File SPR-1995-108

SITE PLAN REVIEW

Project Name: Sports Complex / Park

Re: Response to Site Plan Review Comments for Canyon View Park - File #SPR-95-108(2)

1 PARK ENTRY SIGNAGE

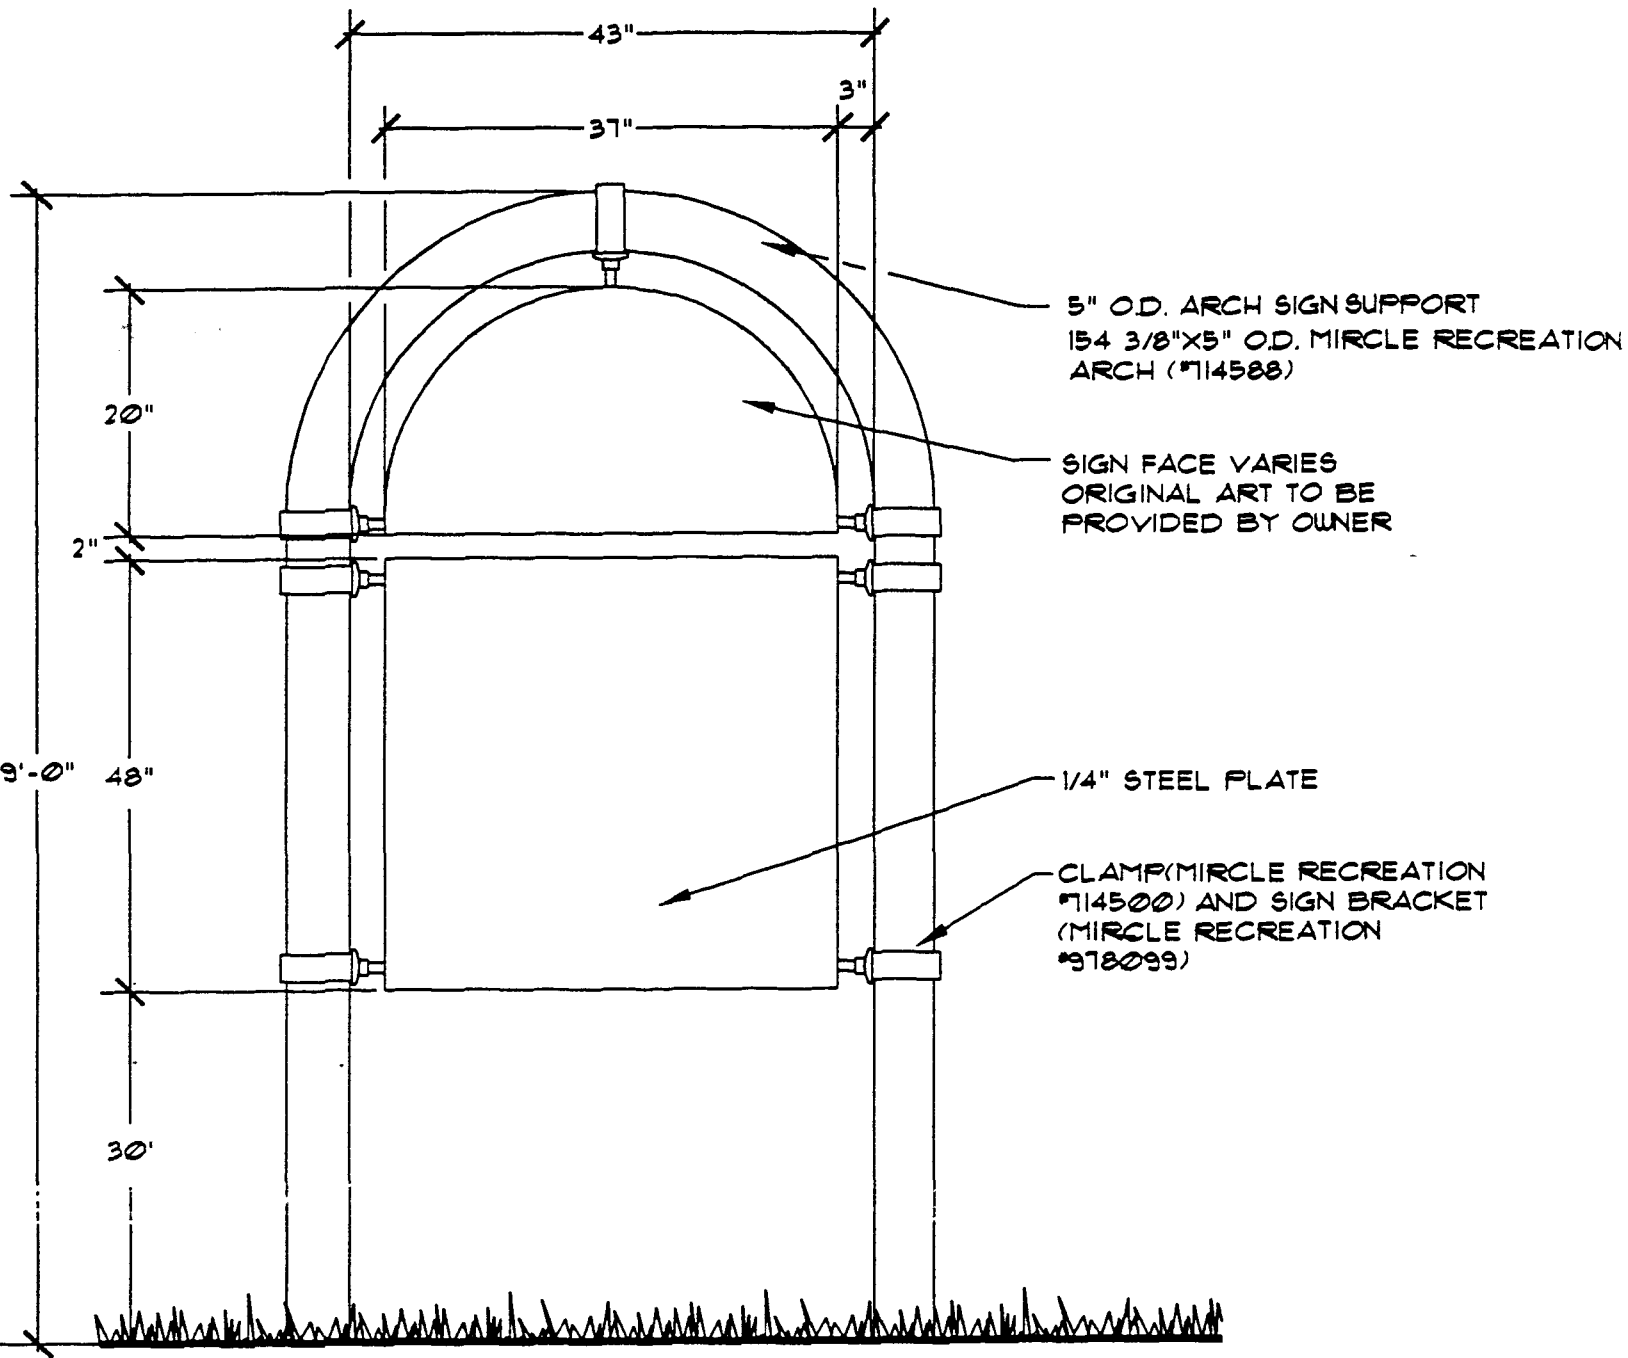
2. I cannot find the proposed locations of the Park Entry sign and Bulletin Board sign on the site plan. Please clarify those locations.
3. Please provide a blow-up of a typical parking lot landscaped island. A 2 1/2 foot paved overhang must be provided on planting islands where vehicle or door overhang is anticipated (section 5-5-1.F.2 of the Zoning and Development Code).
